**NOTICE OF A REGULAR MEETING
BONDURANT PLANNING AND ZONING COMMISSION
SEPTEMBER 8, 2022**

TITLE: -RESOLUTION NO. PZ-220908-25: Considering recommended approval of the site plan for the Midstates Precast Products parking lot and office project at 2340 Hubbell Avenue SW

TITLE: - RESOLUTION NO. PZ220908-26: Considering recommended approval of the Amazon Truck Wash site plan at 2300 Shiloh Rose Parkway SW

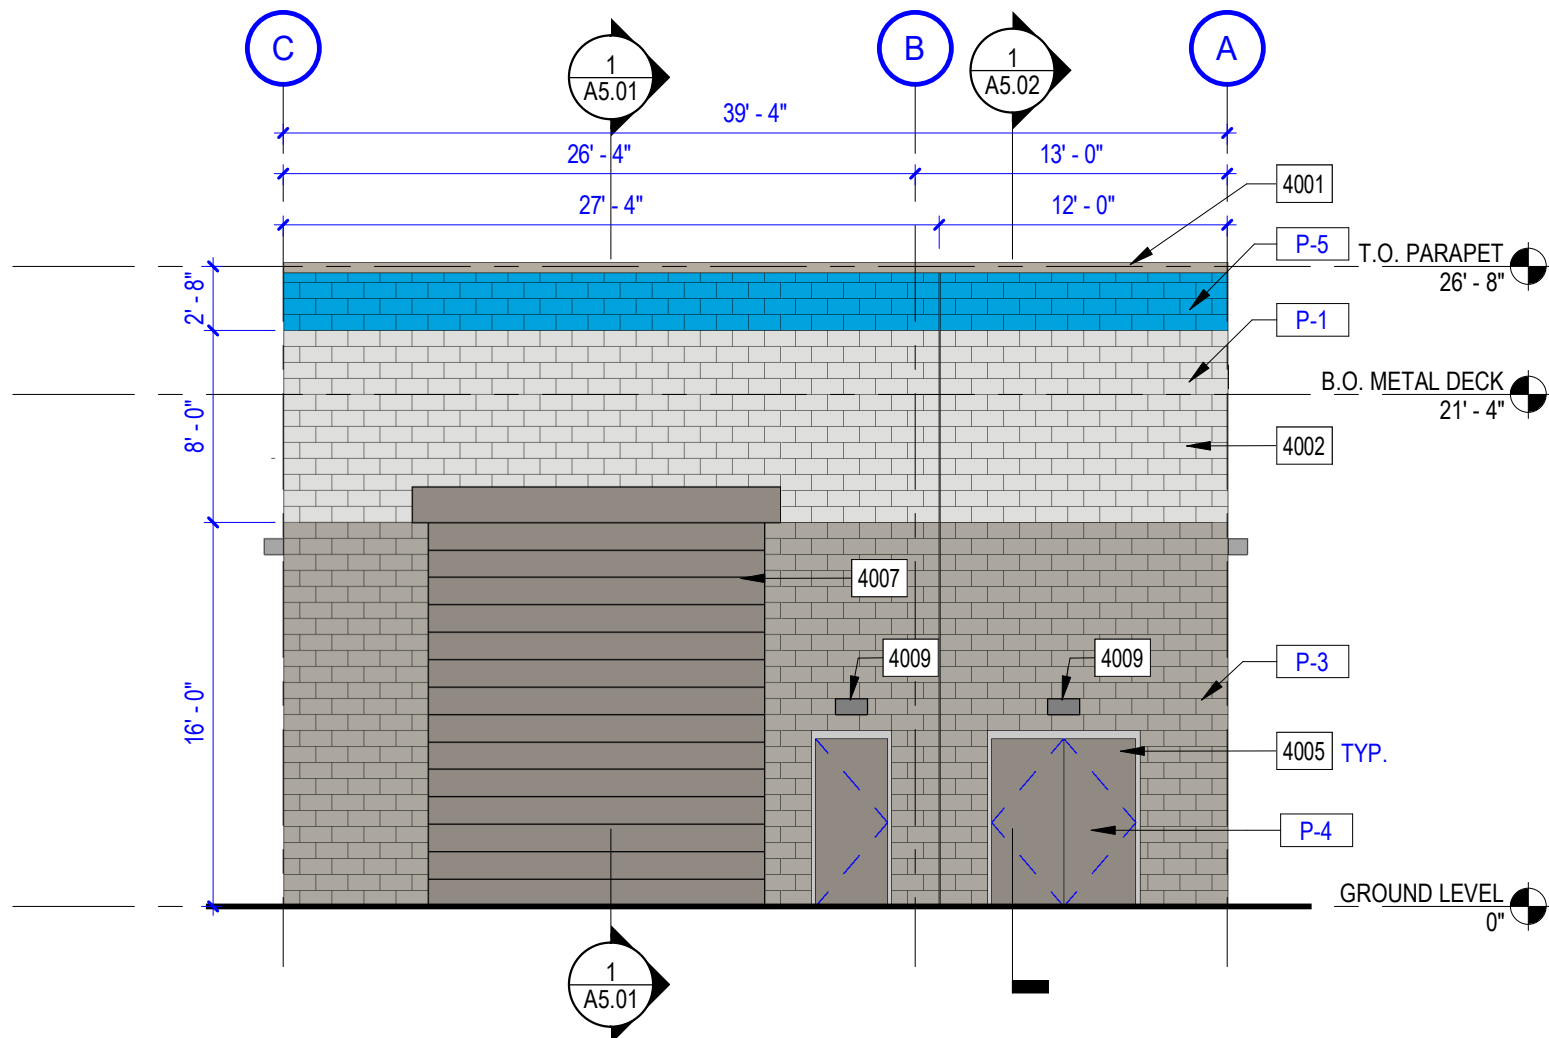
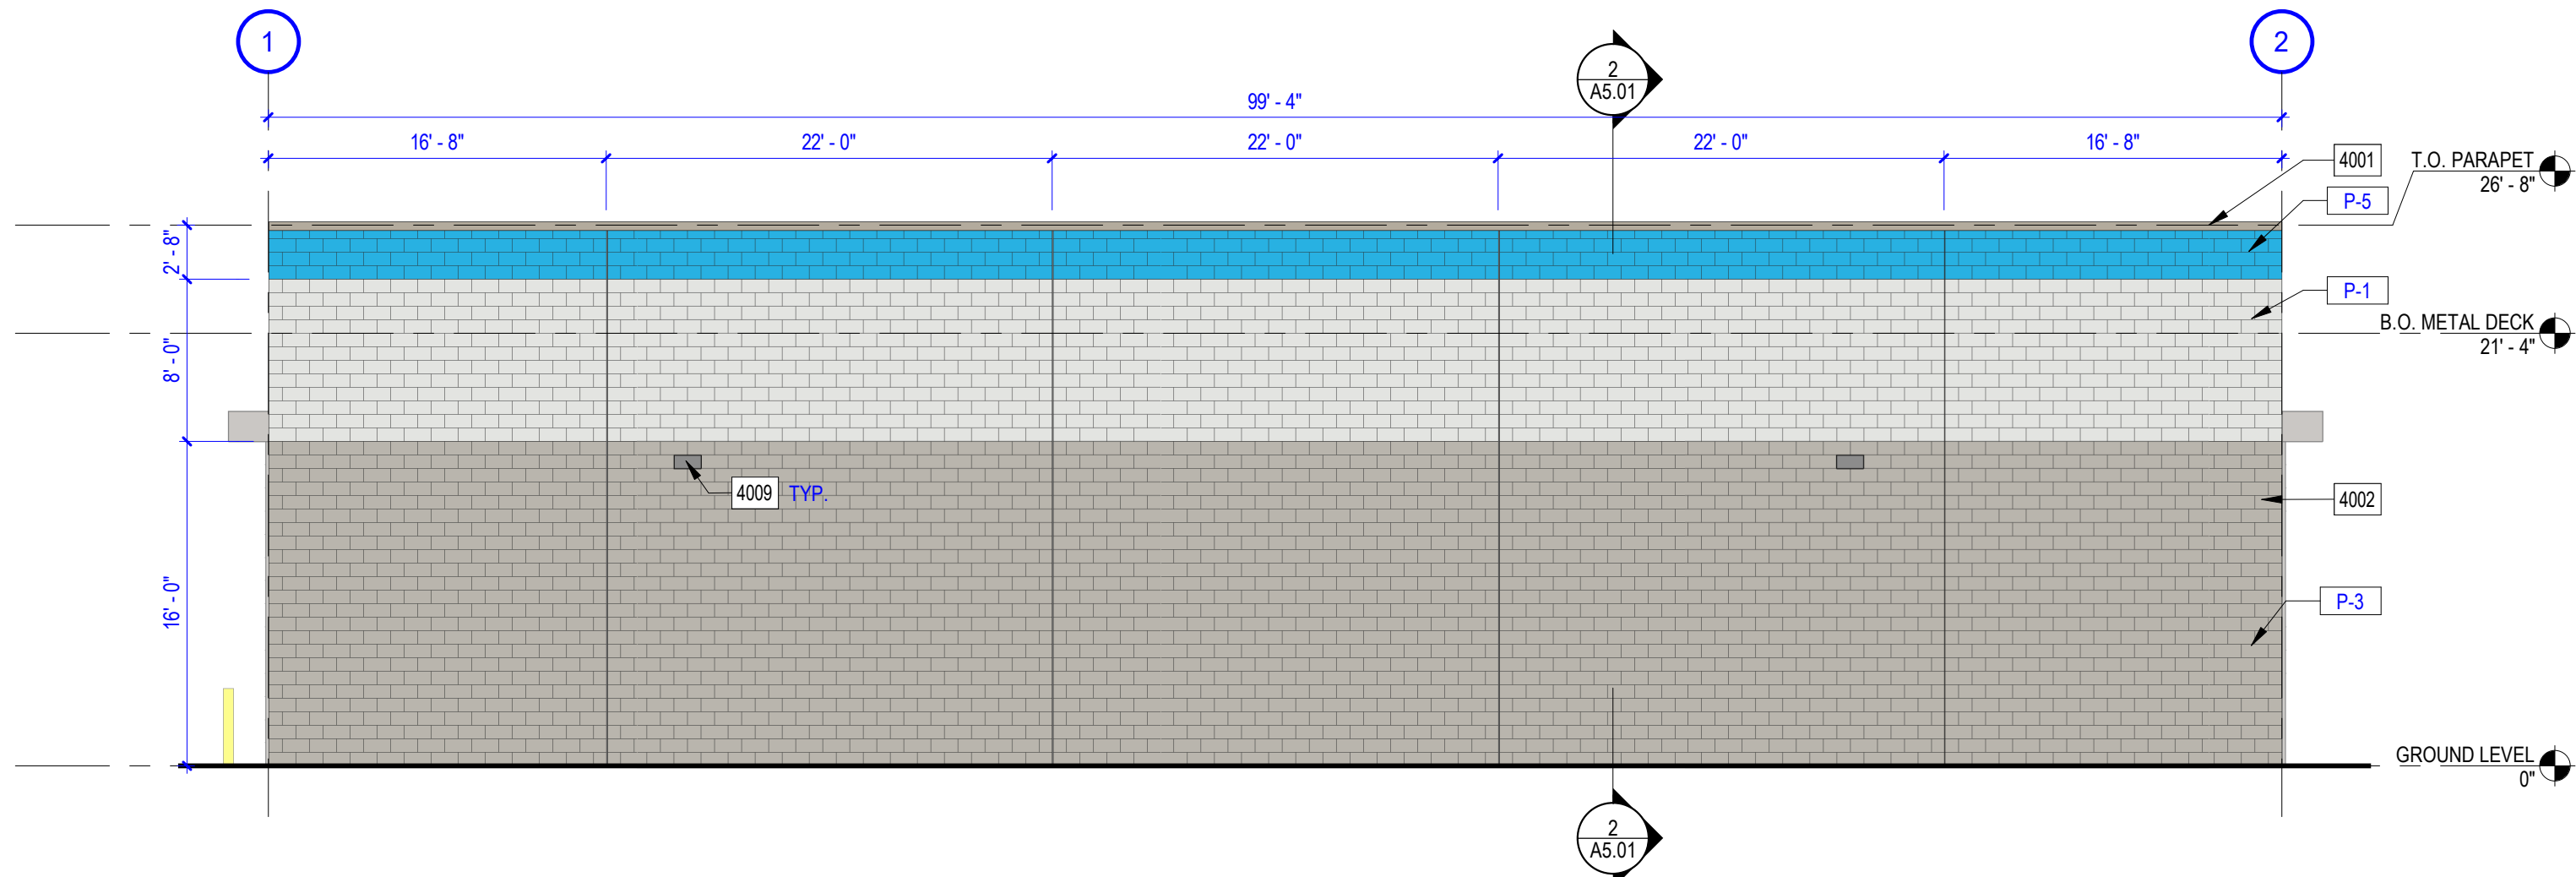
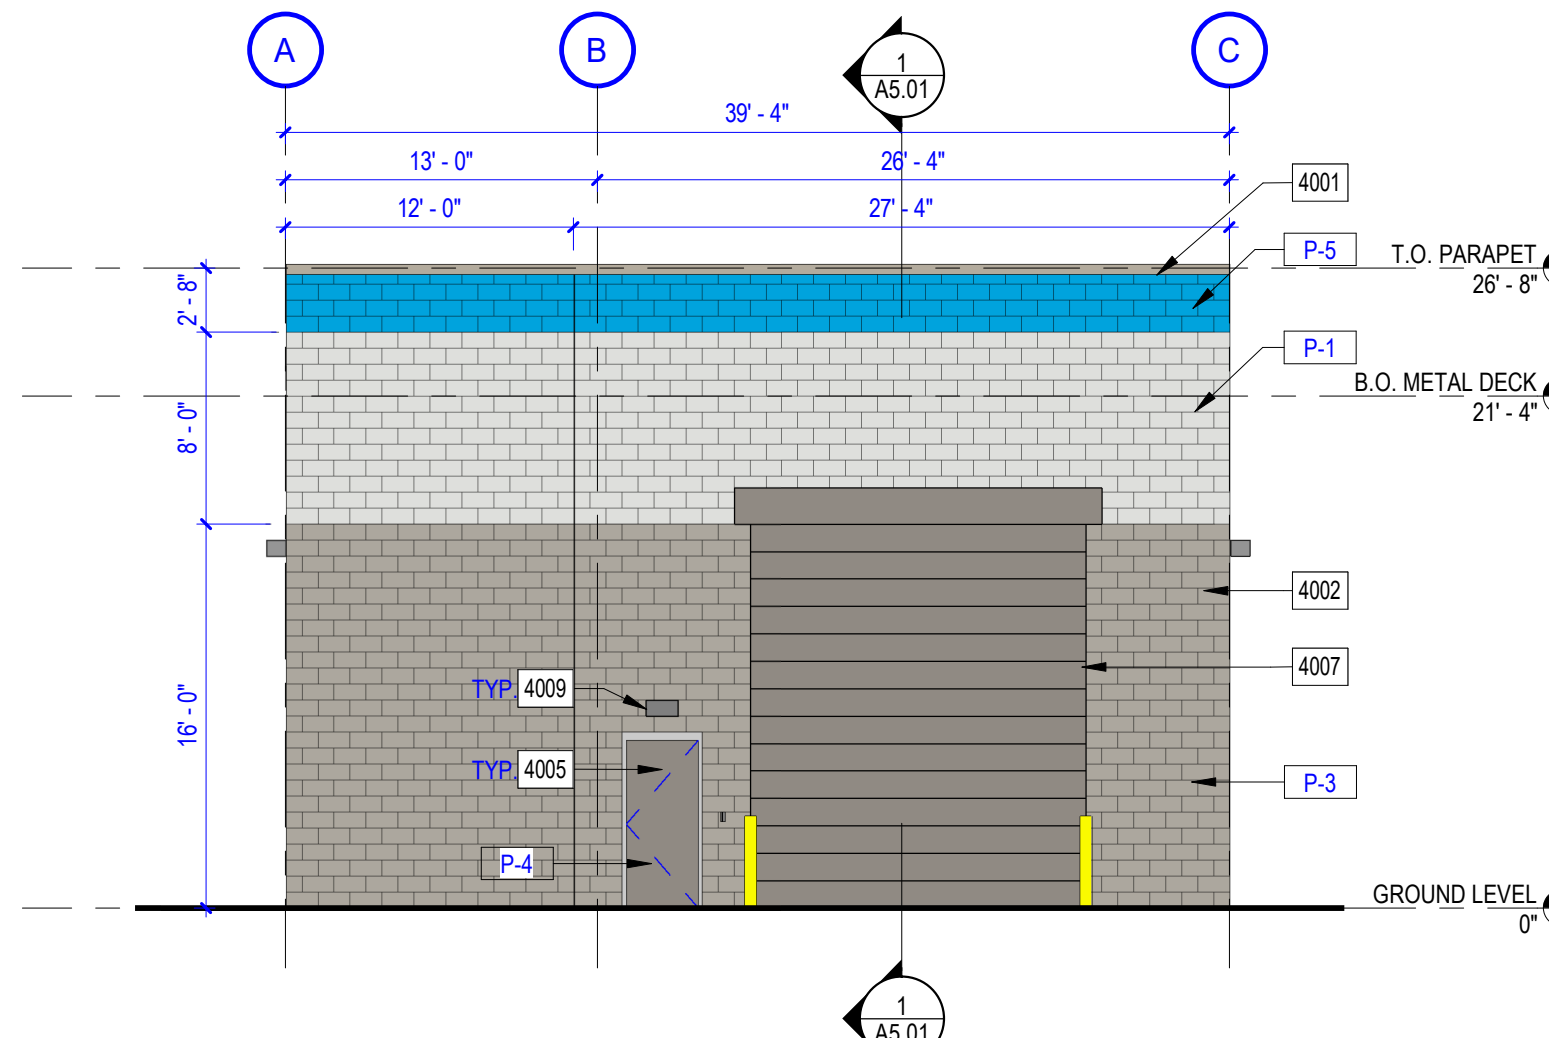
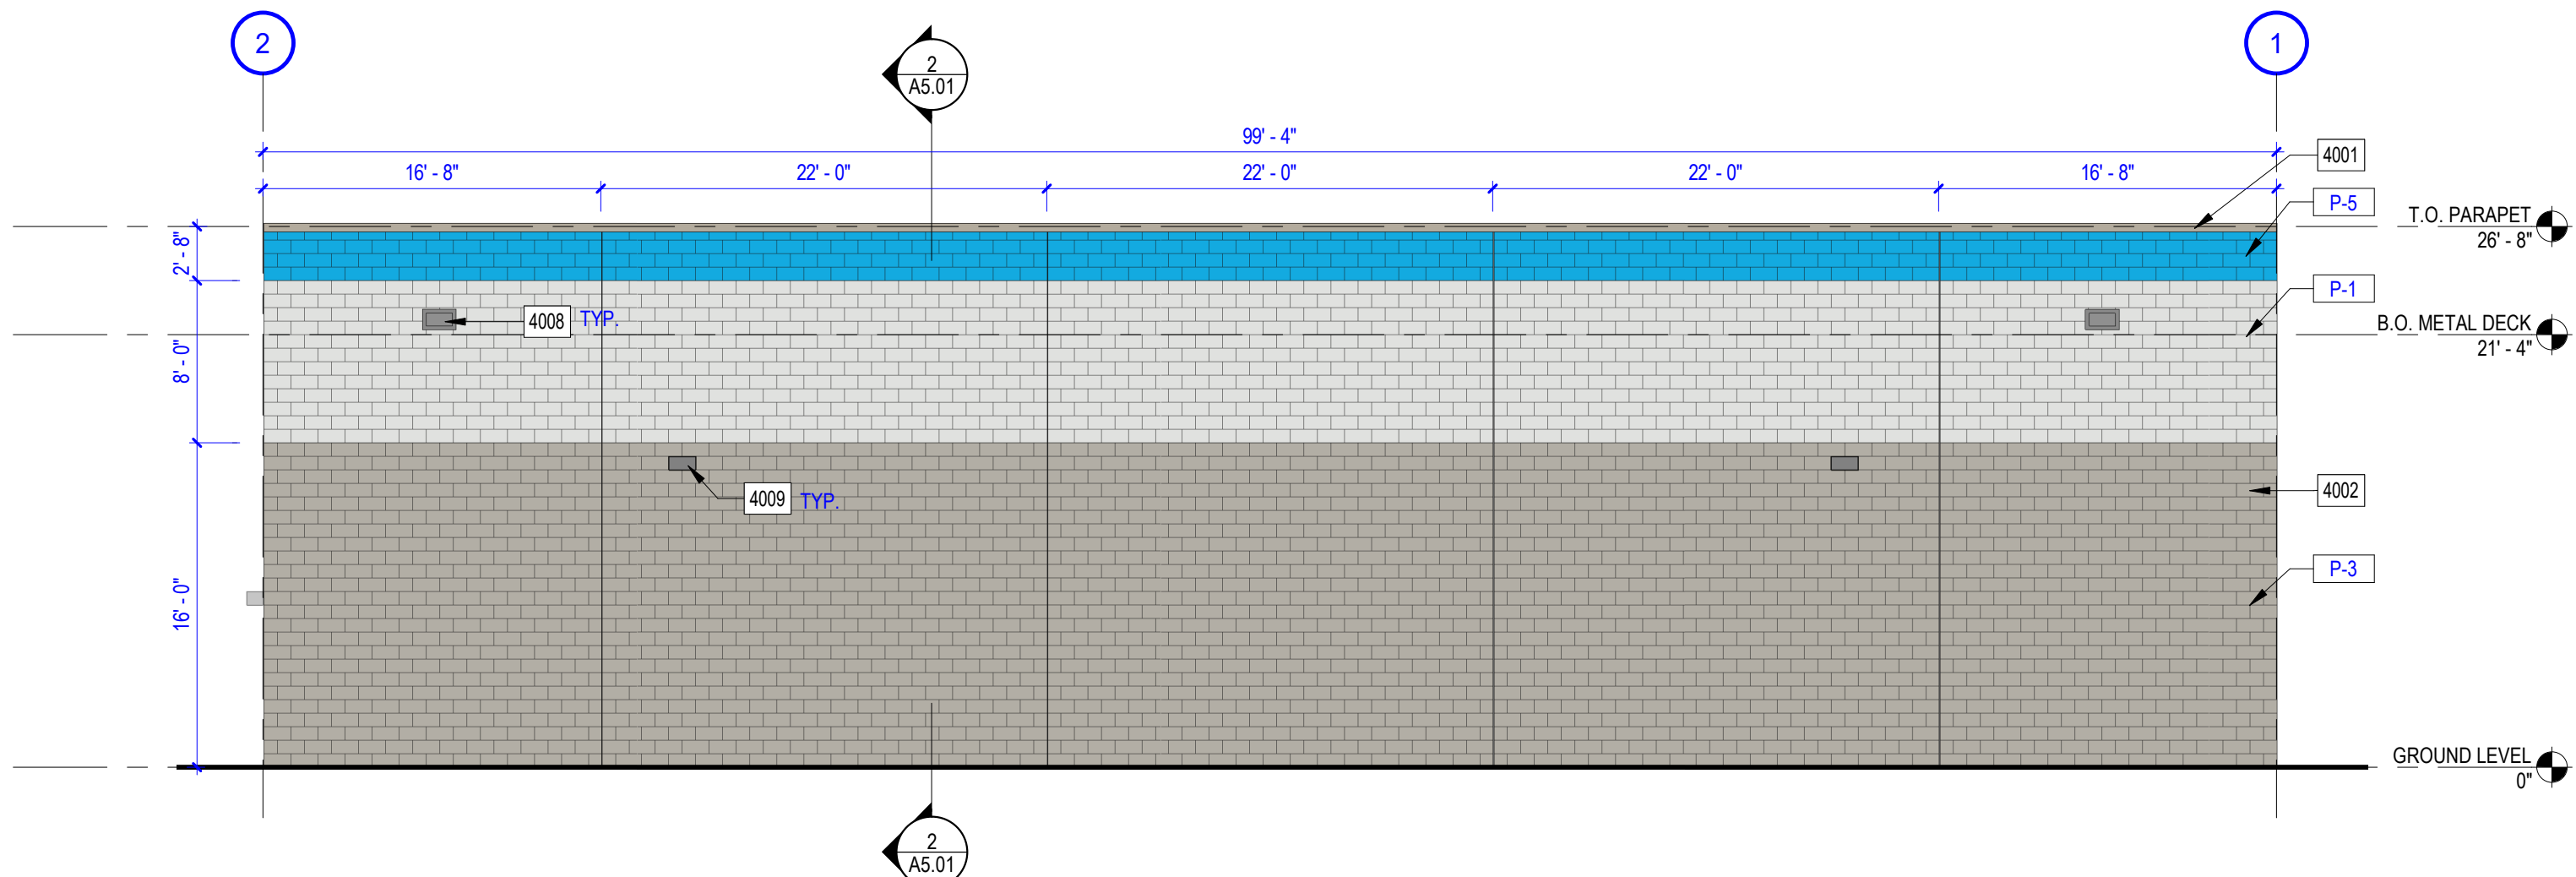
- Roof mounted mechanical units or other roof mechanicals shall be screened from public view by the extension of a parapet wall. Such screening shall have similar design features as the building including material, shape, and color consistencies. *The building elevations do not show any roof mechanicals proposed.*

- Industrial Building Design/Material Requirements (Non-Overlay).
 - Street-facing facades (E, S, W) - at least 50% of the street-facing facades shall be comprised of the following materials: fascia glass, brick, concrete panels, textured concrete block, stone panels, or other similar material. *Building elevations to be updated to clarify that the proposed concrete masonry units will be textured.*

- Non-street facing facades (N) - the street-facing material requirements must be present as at least trim on the non-street facing facades. The remainder of the non-street facing elevation materials may be textured metal panels, architectural metal, or similar material. *Building elevations to be updated to clarify that the proposed concrete masonry units will be textured.*

3 That the building elevations be updated to clarify that the concrete masonry units will be textured, as required by the Industrial District building design/material regulations.
